Title:	Husky XP Transducer Troubleshooting			
Number:	SB_792	Release Date:	06/30/2026	
Revision Number:	Not Applicable	Revision Date:	Not Applicable	
Chassis Type:	All Chassis			
Component Description:	Husky XP transducer			
Parts:	Existing Transducer: Transducer,XP,FSC,Bellows (PN 3594489) Replacement Transducer (if needed): Transducer,XP,300PSI (PN 5027449)

Husky XP pressure transducer troubleshooting procedure for transducer-related performance concerns.

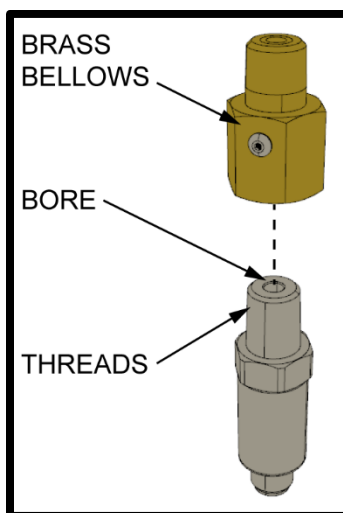
Recent field experience has identified that the bellows assembly incorporated into pressure transducer PN 3594489 may contribute to performance concerns within the Husky XP foam system. An updated transducer, PN 5027449, has been released which utilizes the same base transducer design without the bellows assembly. This bulletin provides the approved troubleshooting and repair process to be used when directed by Pierce Technical Support.

Step 1 - Modify Existing Transducer

Before replacing the transducer, attempt the following corrective action using the existing transducer (PN 3594489):

1. Remove the pressure transducer from the Husky XP foam system.
2. Remove the brass bellows assembly from the transducer.
3. Flush the internal bore of the transducer using brake cleaner or equivalent solvent cleaner.
4. Allow the transducer to dry completely.
5. Remove any remaining red thread locker from the NPT threads using a wire brush.
6. Reinstall the modified transducer.
7. Return the unit to service and verify proper system operation.
